CONSTRUCTION PLANS
FOR
THE RIDGE AT LORSON RANCH FILING NO. 2

STREET & STORM SEWER CONSTRUCTION PLANS

SF 22-005

**THE RIDGE AT LORSON RANCH FIL NO. 2
STREET & STORM SEWER
CONSTRUCTION PLANS**

**TYPICAL SECTION 60' R.O.W.
RESIDENTIAL URBAN COLLECTOR**
NOT TO SCALE

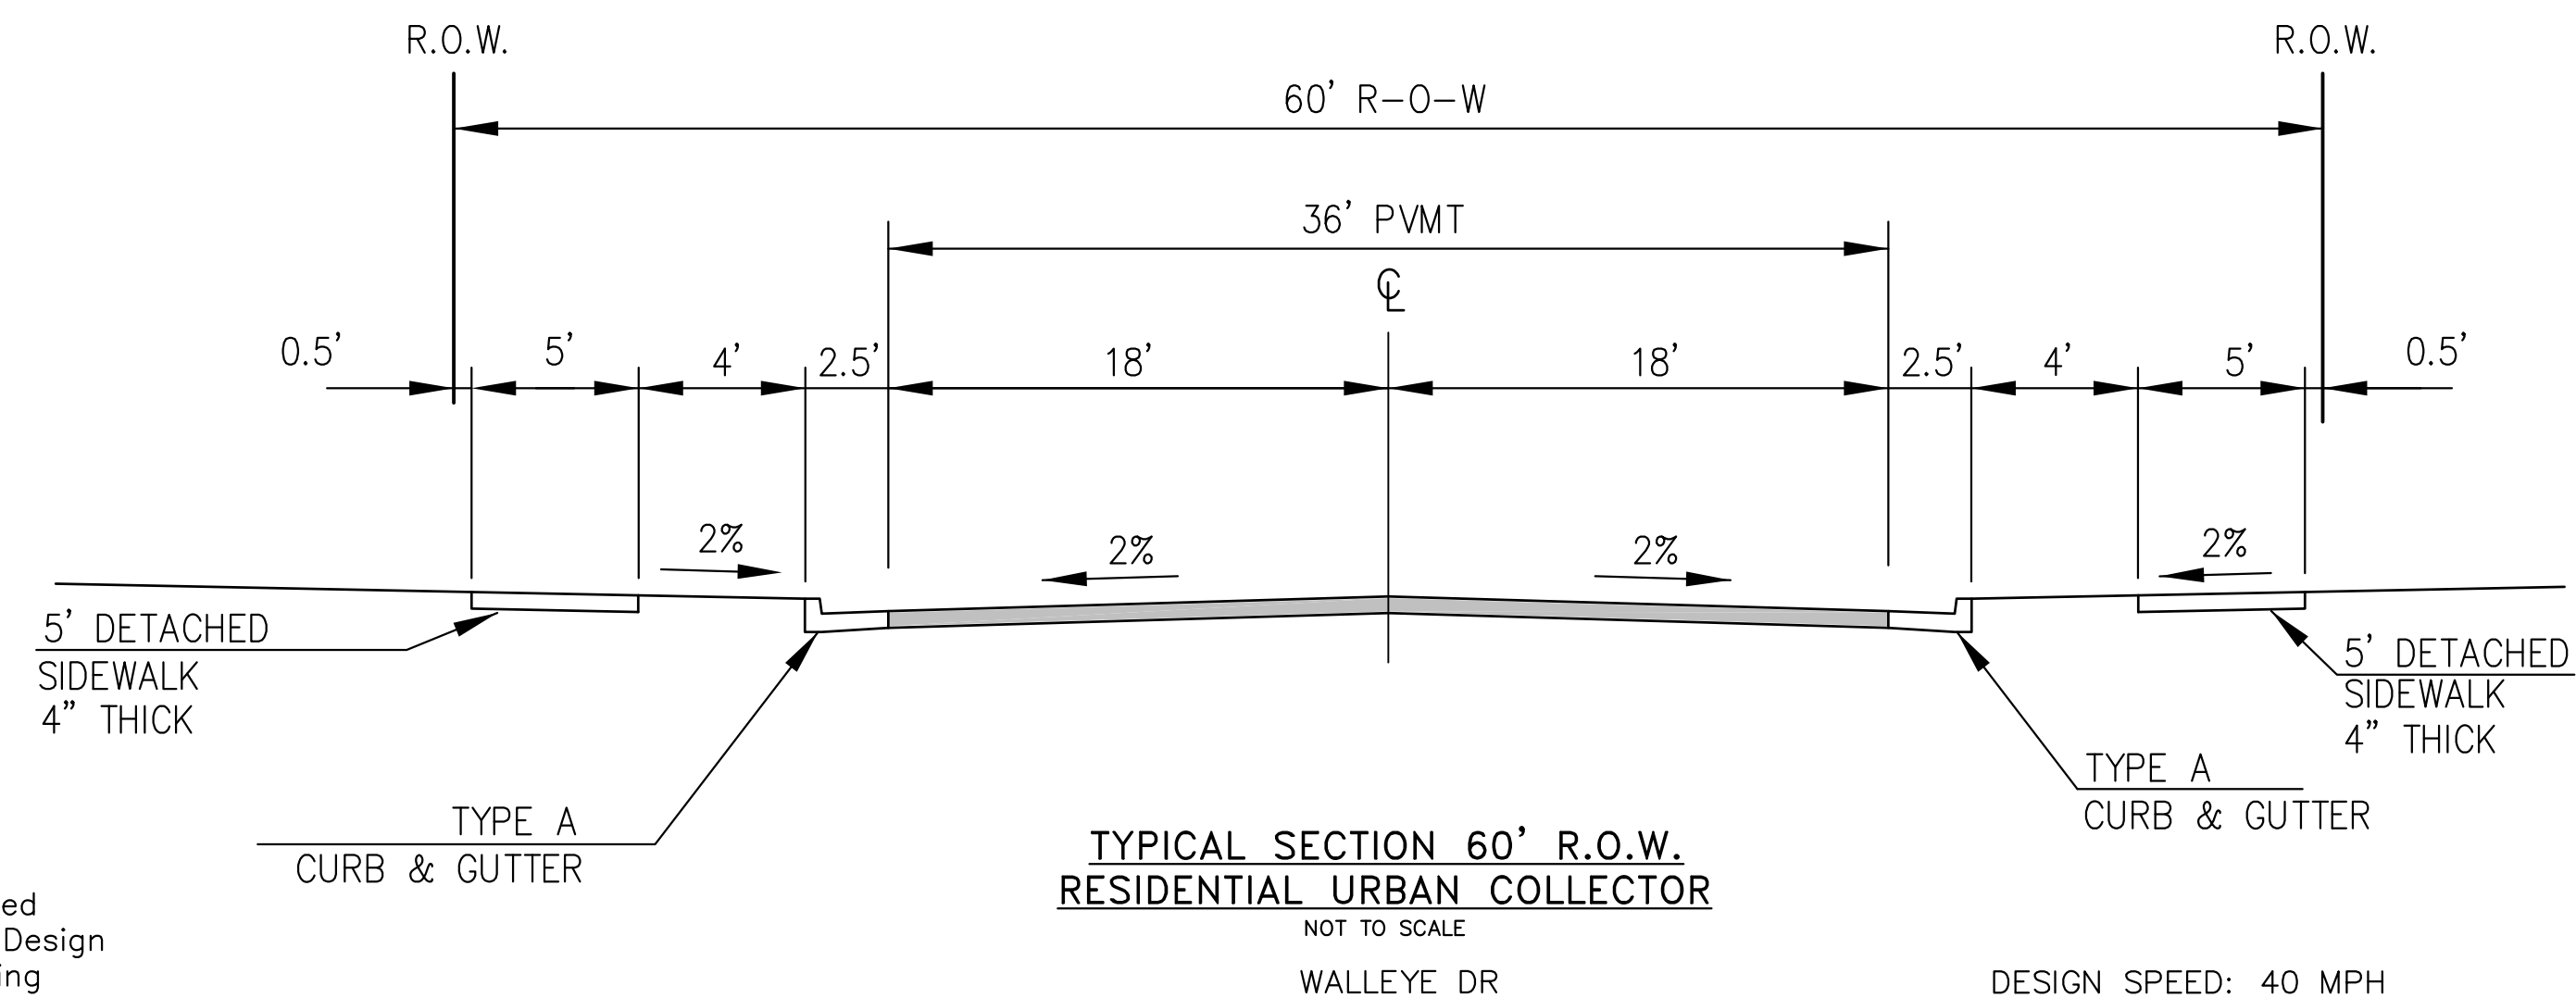
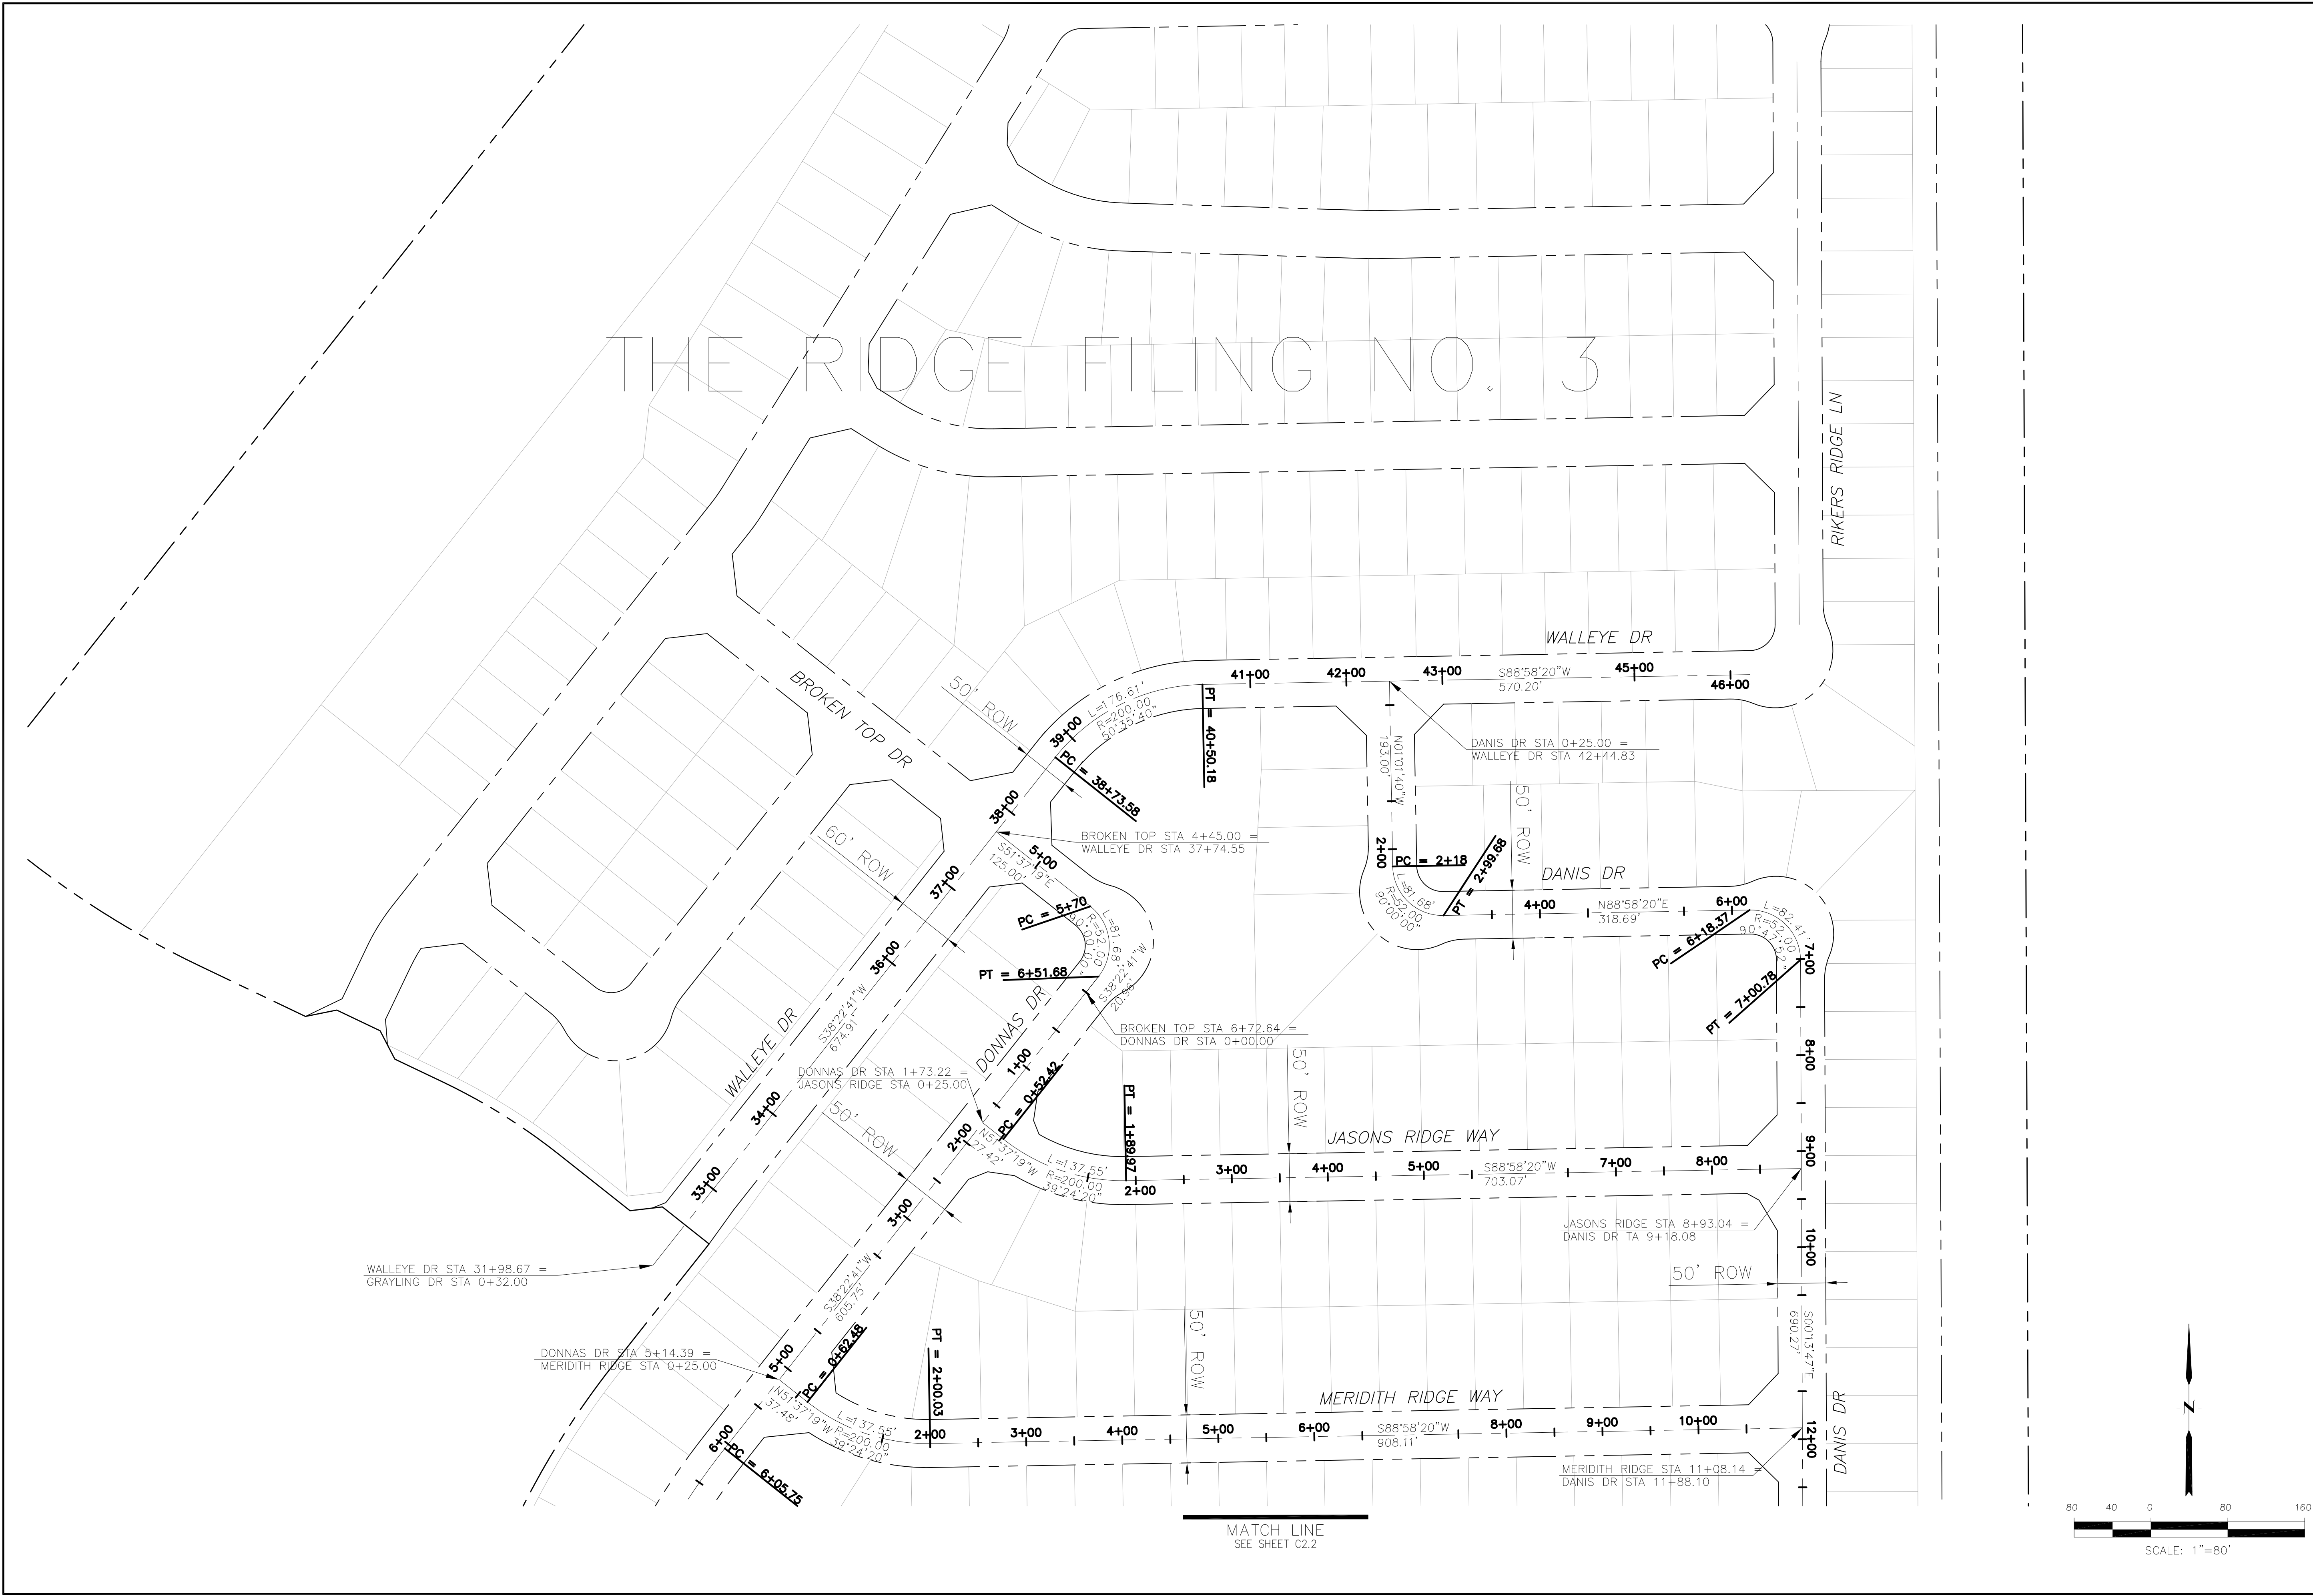
According to
comment responses,
Walleye was
downgraded to a local
street. Please revise
and update posted
and design speeds.

STREET / STORM - NORTH AREA
 BROKEN TOP DRIVE
 STA 0+00 TO 6+72

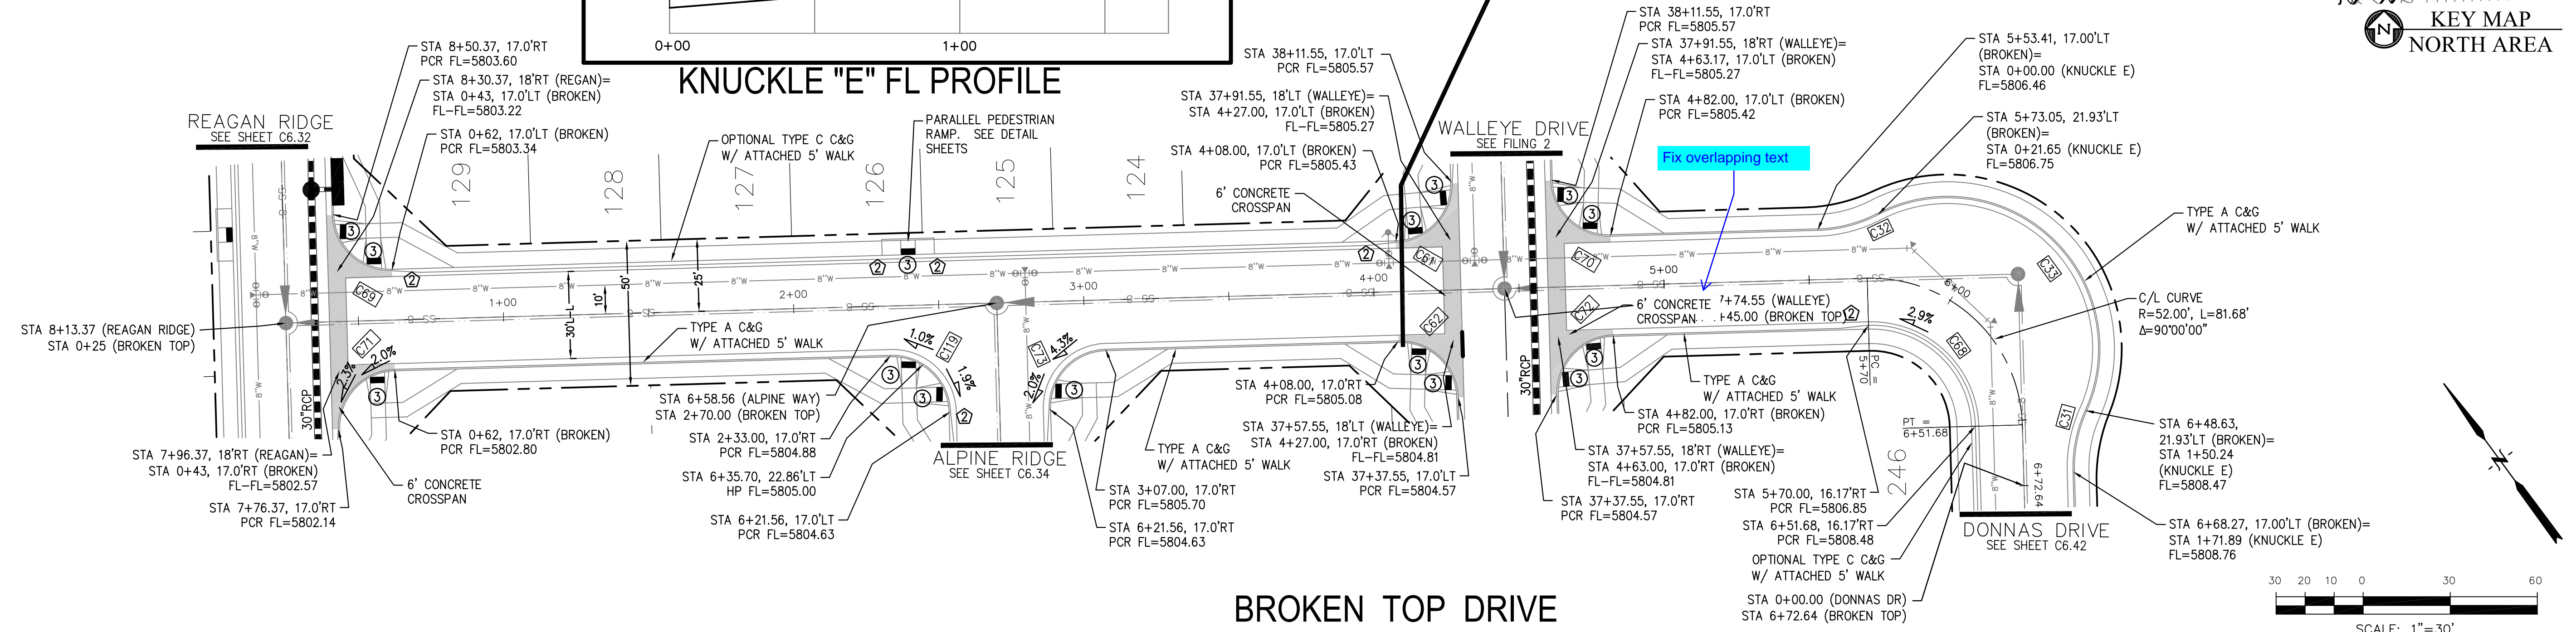
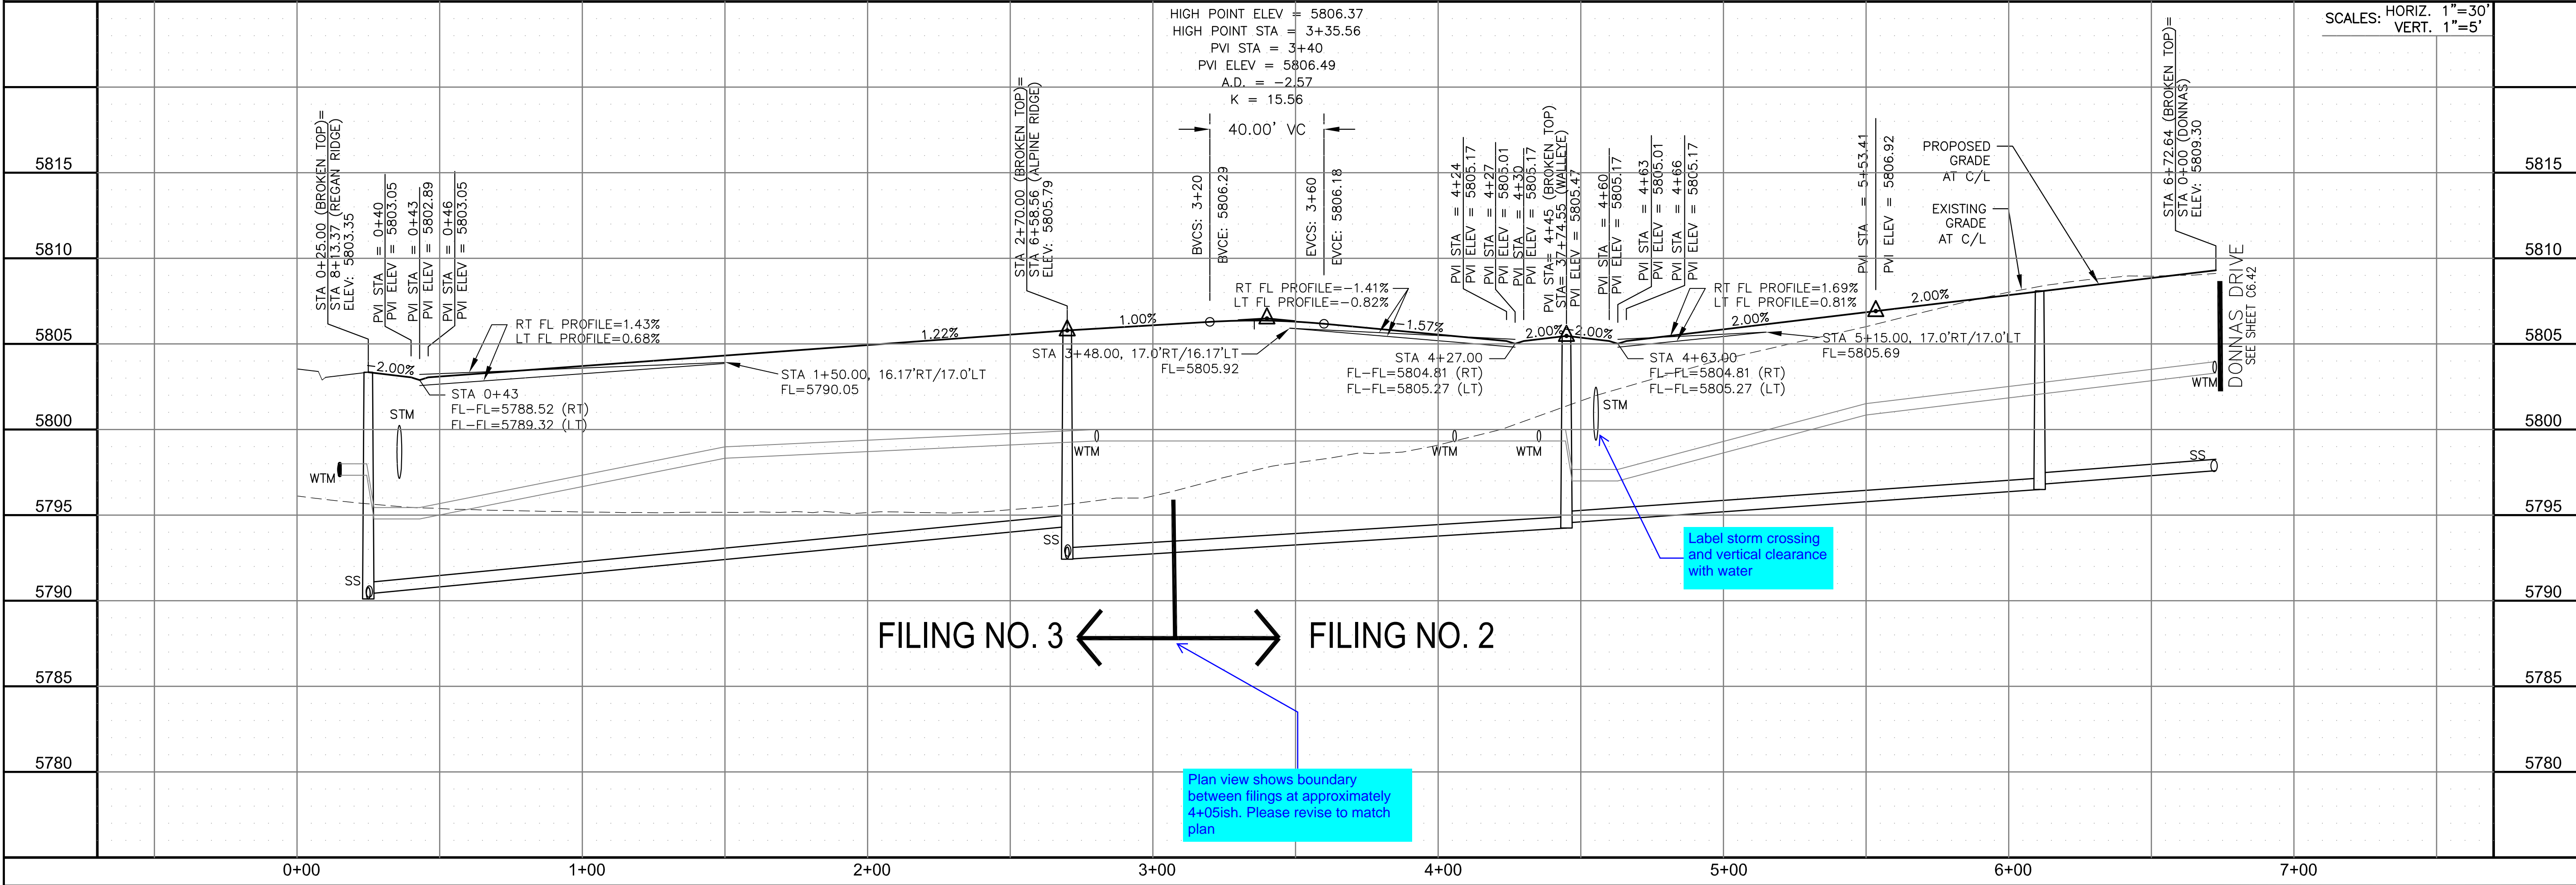
Label storm crossing and vertical clearance with water

Plan view shows boundary between filings at approximately 4+05ish. Please revise to match plan
